RESPONSE TO REQUEST FOR INFORMATION

DATE: May 26, 2016 **RFI No.** 010

PROJECT: **Waitsfield BRF 013-4(39) - Bridge No. 177**
VT Route 100 over Mad River

RE: RFI #10: Precast Footing Projecting Bars for CIP Return Wall
Footing & Wingwall Keyway at Closure Pour Interface

5-26-16 J. P. Carrara & Sons, Inc.
 Waitsfield BRF 013-4(39) Abutment #1
 JPC RFI #10, Partial FG3 Drawing
 Precast Footing Mark No. 'MD-FG3'
 Add (9) #5 Projecting Bent Bars &
 Roughened Surface at Cast-in-Place
 Return Wall Interface

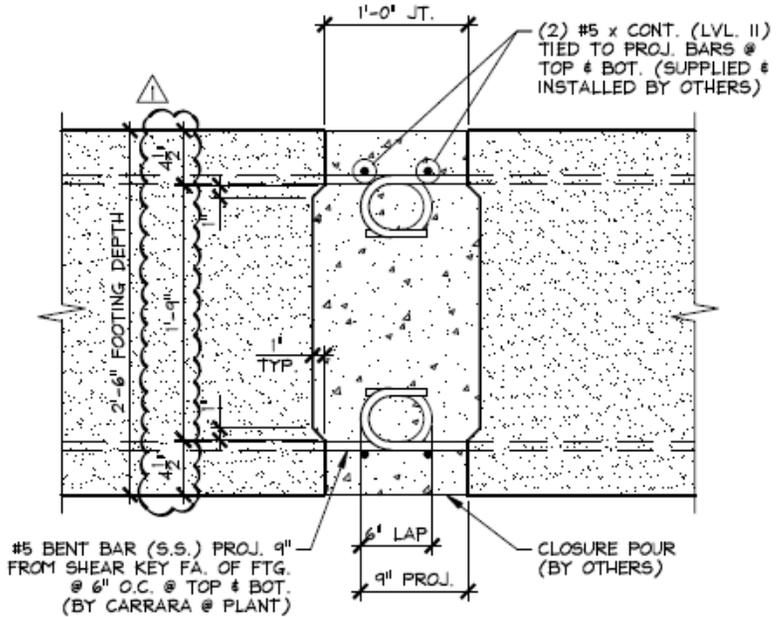
J. P. Carrara & Sons, Inc. "JPC" proposes to add (9) each projecting #5 bent bars, mark 'MD-590S' as shown on the attached partial 'FG1' and 'FG3' sketches in each of mark number 'MD-FG1' and 'MD-FG3' precast footings respectively, at the interface between the precast footing and the cast-in-place return wall. JPC also proposes to add a roughened finish with a ¼" amplitude to the top surface of the precast footing at the interface of the return wall.

Response: MJ has reviewed the attached RFI request regarding the proposed footing projecting bars and finds the details shown acceptable. MJ has also reviewed the proposed keyway details and finds the details acceptable.

JPC RFI #10, Partial Drawing F3.2; 'MD-WW1', 'MD-WW2', 'MD-FG1',
 'MD-FG2', 'MD-FG3':
 Modify Shear Key to Extend to Inside Face of Projecting Reinforcement

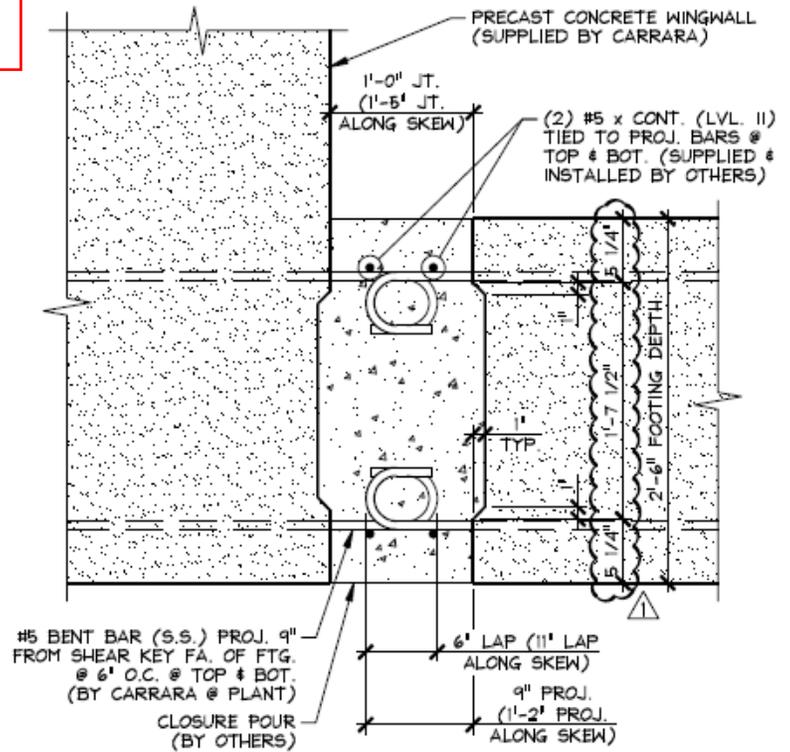
J. P. Carrara & Sons, Inc. "JPC" also proposes to modify the precast footing and and wingwall keyway length at the closure pour locations to extend from the inside face to inside face of projecting reinforcing bars, similar to the detailing used for the approach slabs. See partial JPC drawing F3.2 attached.
